**Meeting Date:** Thursday 14 March 2019  
**Location:** Council Chambers, Level 1A, 1 Pope Street, Ryde  
**Time:** 5.00pm

### **2 17 SHUMACK STREET, NORTH RYDE - DEMOLITION OF STRUCTURES AND CONSTRUCTION OF AN ATTACHED DUAL OCCUPANCY WITH PARKING - LDA2018/0348**

### **City of Ryde Local Planning Panel Report**

<b>DA Number</b>	<b>LDA2018/348</b>
<b>Site Address &amp; Ward</b>	<b>17 Schumack Street, North Ryde – East Ward</b>
<b>Zoning</b>	<b>R2 Low Density Residential</b>
<b>Proposal</b>	<b>Demolition of structures and construction of an attached dual occupancy with parking</b>
<b>Property Owner</b>	<b>Limin Li</b>
<b>Applicant</b>	<b>ARC Homes</b>
<b>Report Author</b>	<b>Natalie Camilleri – Senior Town Planner</b>
<b>Lodgement Date</b>	<b>4 September 2018</b>
<b>No. of Submissions</b>	<b>Five (5) submissions</b>
<b>Cost of Works</b>	<b>\$800,000.00</b>
<b>Reason for Referral to LPP</b>	Development that contravenes a development standard imposed by an environmental planning instrument by more than 10% or non-numerical development standards.

**Figure 15 – Shadows cast over No. 7 Farnell Street on 21 June.**

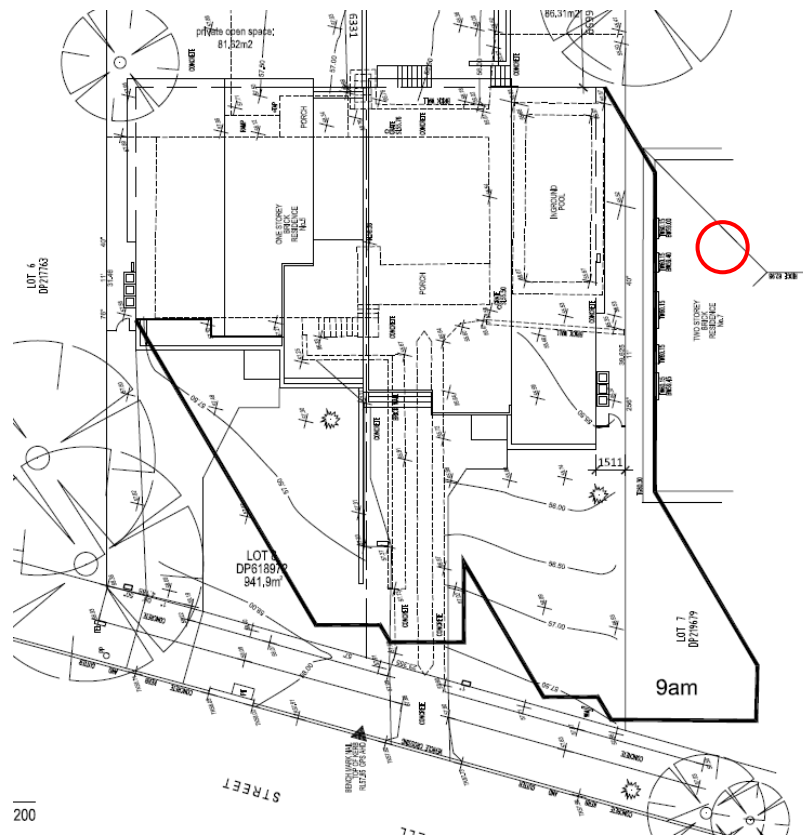
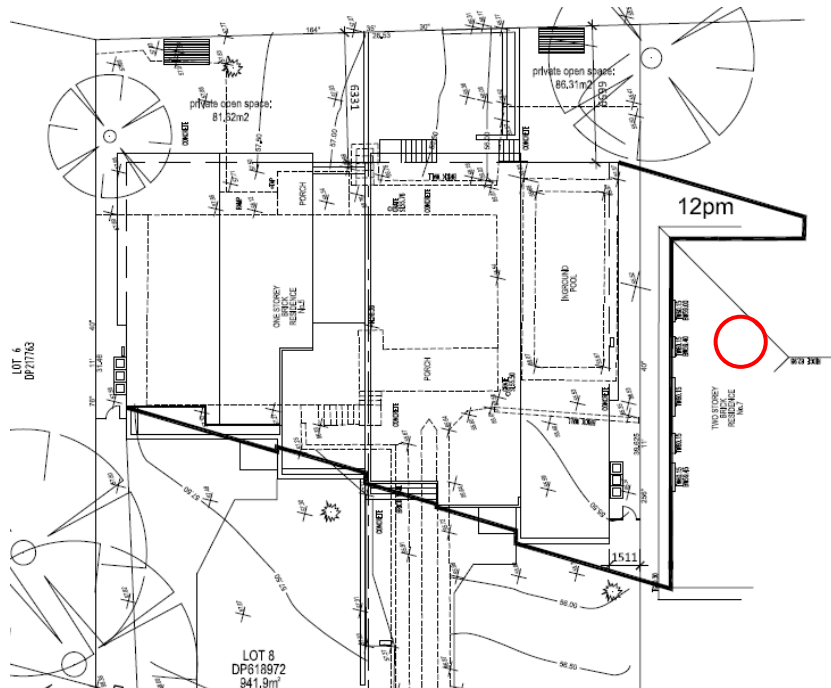
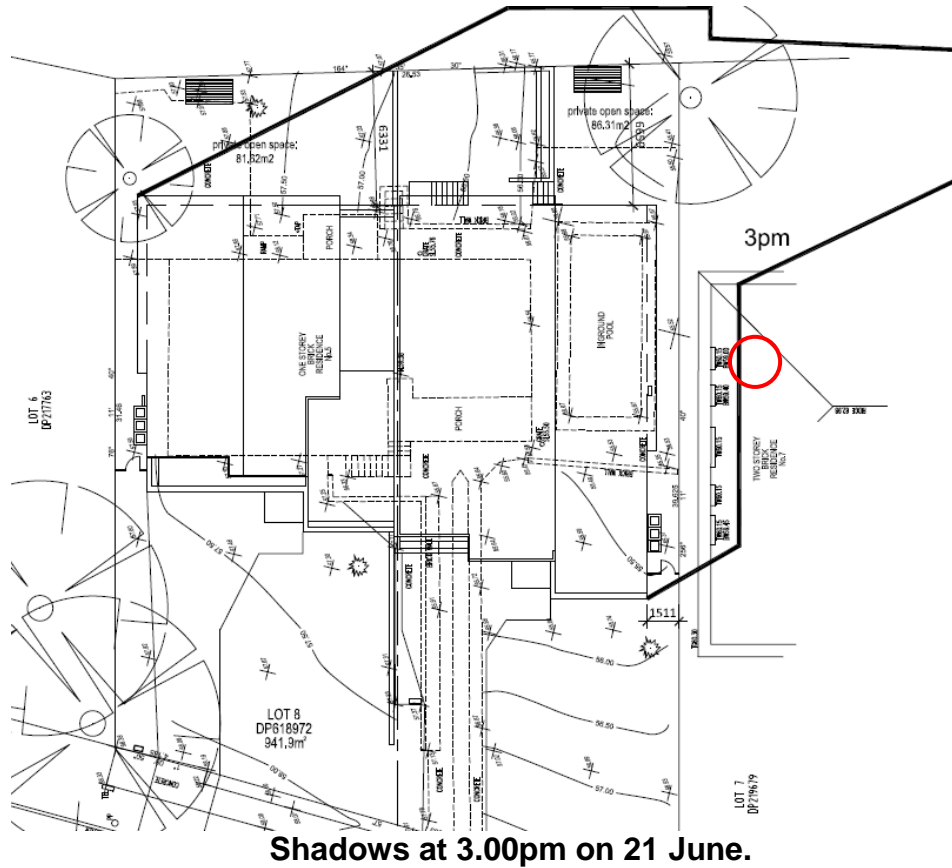
Given the orientation of the site, and the close proximity of the north facing windows of No. 7 Farnell Street, the kitchen window (as identified in **Figure 15**) of No. 7 Farnell Street is affected by overshadowing.

The proposal results in the kitchen window (as identified in red in **Figure 15**) receiving 2.5 hours of sunlight on June 21, as demonstrated in the elevational shadow diagrams in **Figure 16**. Therefore, the proposal does not provide the required 3 hours sunlight to the kitchen window of No. 7 Farnell Street, and does not comply with this control.

**Figure 16:** Elevational shadow diagrams assessing impact on No. 7 Farnell Street

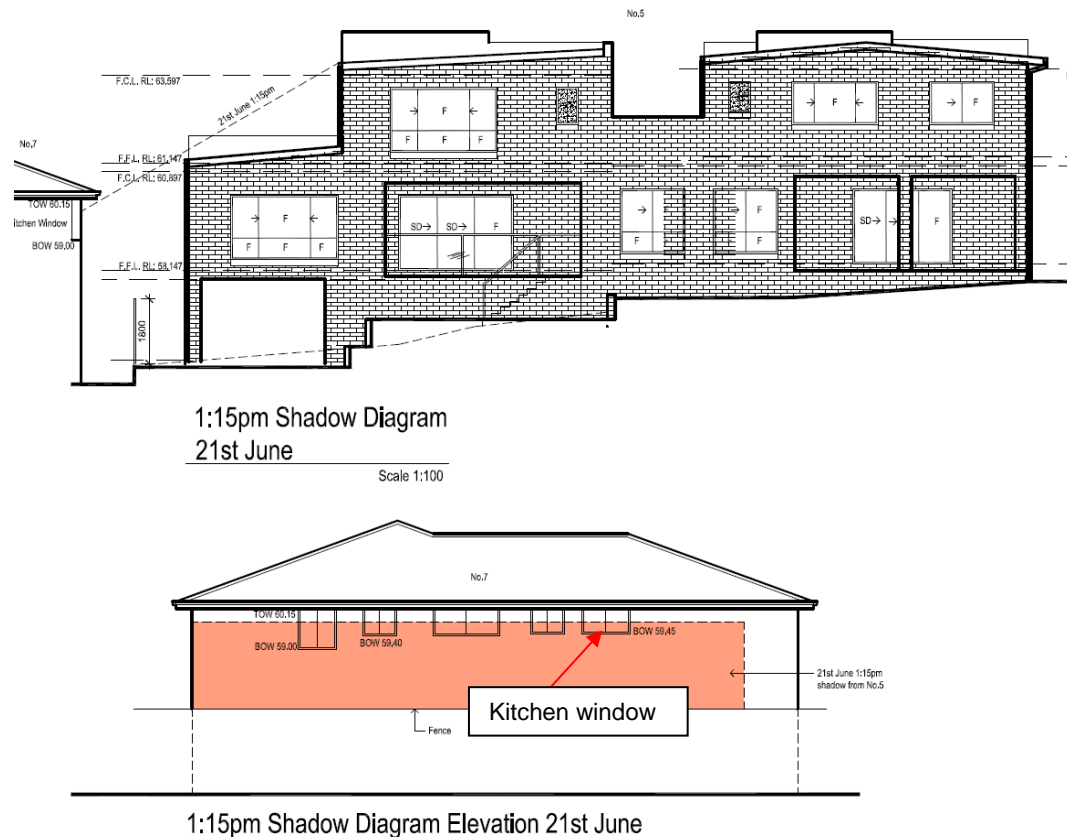
As shown in **Figure 16**, the kitchen window receives a total of 2.5 hours sunlight to a portion of its surface between the hours of 10:45am and 1:15pm.

**Figure 24:** Lower floor plan showing door from entertainment area to subfloor

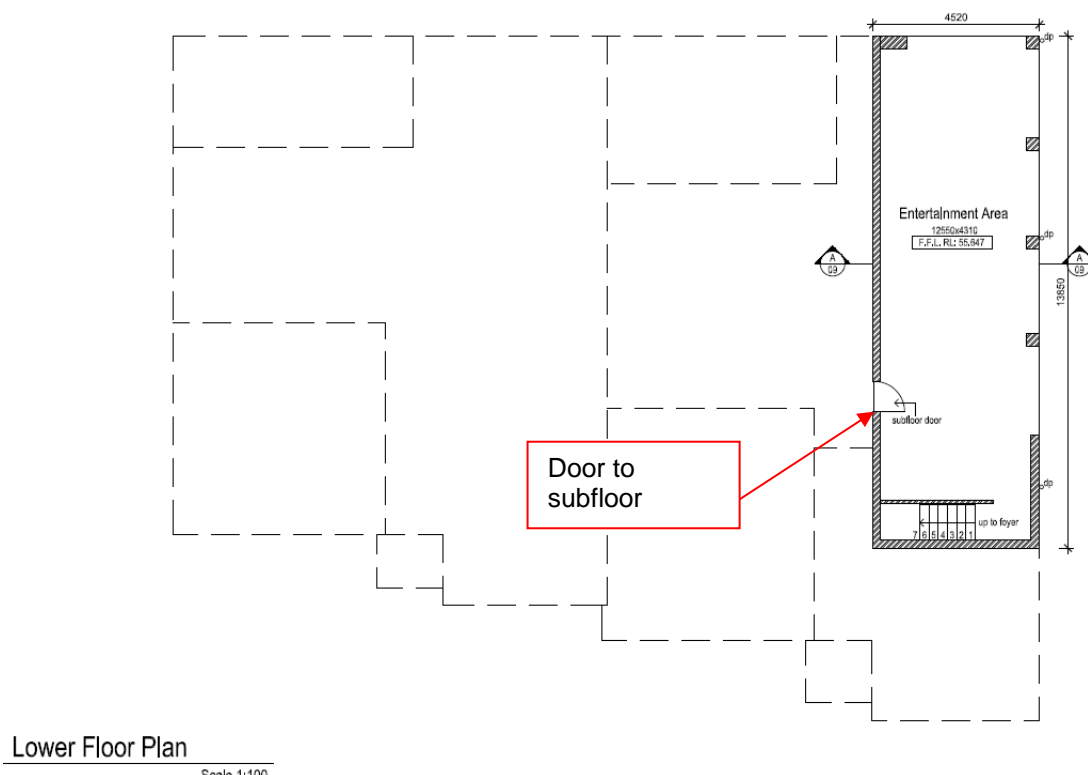
Concern was raised that the sub-floor area connecting to the entertaining area (as shown in **Figure 24** and **25**) has a height of 2.4m in some sections, and should be included within the gross floor area calculations. The submission raised concern that, given the height of the subfloor, this effectively would act as a third storey, and be used as an extension of the entertaining area.

As per the definition of 'floor' and 'gross floor area' previously provided in this report, the area of the subfloor area is not considered to be a floor, as this area has a maximum floor to ceiling height of 2.25m, and does not meet the minimum floor to ceiling requirement for habitable rooms under the Building Code of Australia (BCA).
